Feasibility Report Addendum 01 -
Proposed Eastern Expansion
(WDNR License No. 3268)

Vernon County Landfill

VERSW 167824 | November 19, 2024

RE: Vernon County Landfill
Feasibility Report Addendum 01 -
Proposed Eastern Expansion
(WDNR License No. 3268)
Viroqua, Wisconsin
SEH No. VERSW 167824 4.00

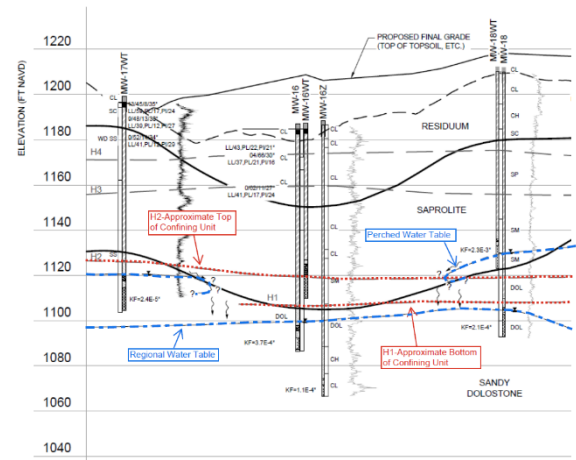
1. **WDNR Comment 1:** Generally, there are a number of gaps in the geologic and hydrogeologic information presented within the feasibility report. Items that remain not well understood include groundwater flow conditions around the southeast corner of the expansion area where SEH has interpreted a merger zone between the perched and regional aquifers. Groundwater flow information presented here appears to be largely interpretive given the number of data points available. For example, you have defined equipotential lines and a complex groundwater flow regime with very few data points (e.g., MW-12, MW-16, and MW-17WT), most of which are seated outside of the southeast area. The grey area shown on Plan Sheets 4 through 7 indicating the merger zone of the perched and regional water tables, appears to have been defined with a single data point (MW-16) from dry wells. The characterization of this area is further confused by what appears to be a contradiction in the information presented in cross section (Plan Sheet 17, cross section F-F') vs. the water table maps 4-7. In cross-section, the merger point is shown at MW-16, but in maps 4-7 the area of the merger shown in gray is a much larger area. It is not well understood how this interpretation was developed given the lack of corresponding geologic and hydrogeologic data.

The continuity of a perched groundwater system depends on favorable hydrogeologic conditions remaining continuous and consistent. However, at the Vernon County Landfill, the lateral extent of the low permeability unit becomes compromised within a valley where much of the bedrock has weathered into saprolite and residuum (MW-16WT/MW-16/MW-16Z) or where lithology changes (MW-19/MW-19Z). This is clearly illustrated in the geologic cross-section G-G' (Plan Sheet 18) and K-K' (Plan Sheet 22) and shown in the figure to the right.

Across the landfill property, the only location in which the elevation of 1120 feet (H2 marker horizon) has been weathered to saprolite is in the southeast. Based on the water level observations in well nests MW-16WT/-16/-16Z and MW-19/-19Z, it is clear that the intrinsic permeability of the confining unit has been compromised through the weathering process or changes in lithology. Fetter (1988) describes a perched aquifer as where “. . . water moves

Sheet 6 (CWE, Plan of Operations)

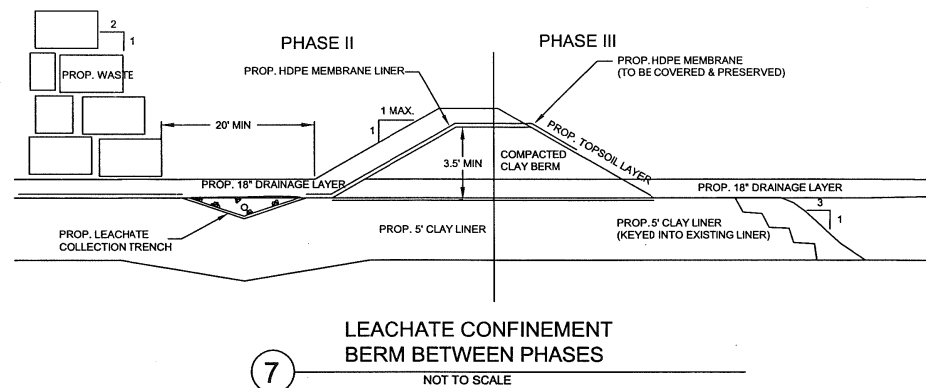
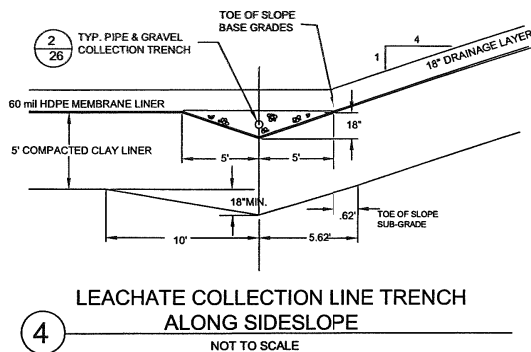
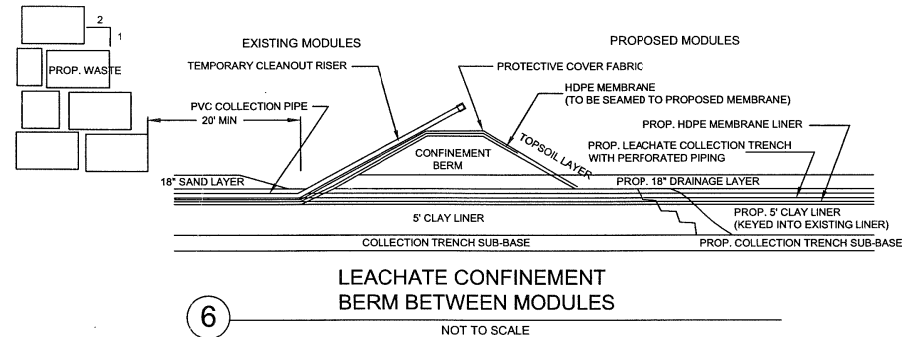
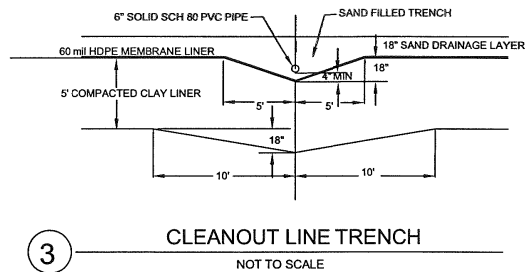
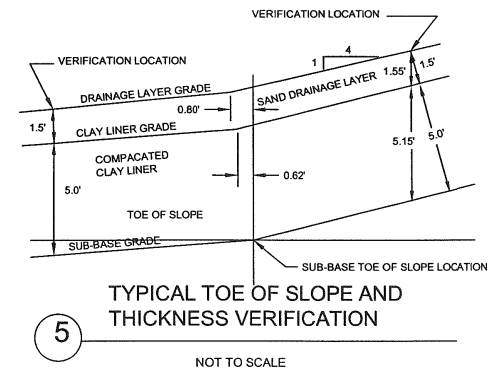
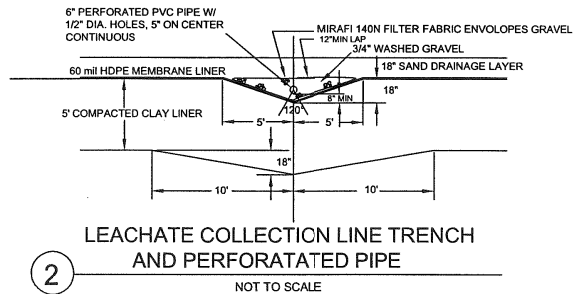
26. **Appendix R, Sub Appendix B, Sheet 16 Leachate Headwells:** This sheet notes that multiple headwells on the landfill are damaged; please provide a current list of the headwells on site and the status of them as well as provide a history of headwells that are damaged, lost, or abandoned.

A Plan Modification Request was submitted to the WDNR on October 2, 2020, summarizing the status of the headwells and requesting approval to use alternatives. This Plan Modification Request proposed to perform head monitoring at leachate cleanouts CO-3S, CO-7S, CO-3N, and CO-6N and leachate headwells LHW-5 and LHW-6. This Plan Modification Request was approved by the WDNR on February 9, 2021. The Plan Modification Request and the WDNR Approval Letter are included within **Appendix I**.

- Sheet 6 shows the designed location and alignment of the leachate headwells and liner contours
- Sheet 16 provides the location and the designated leachate head well names and clean out monitoring locations
- Sheet 25 and Sheet 29 provide design details, as presented in the plan of operations, for the leachate collection and monitoring system.
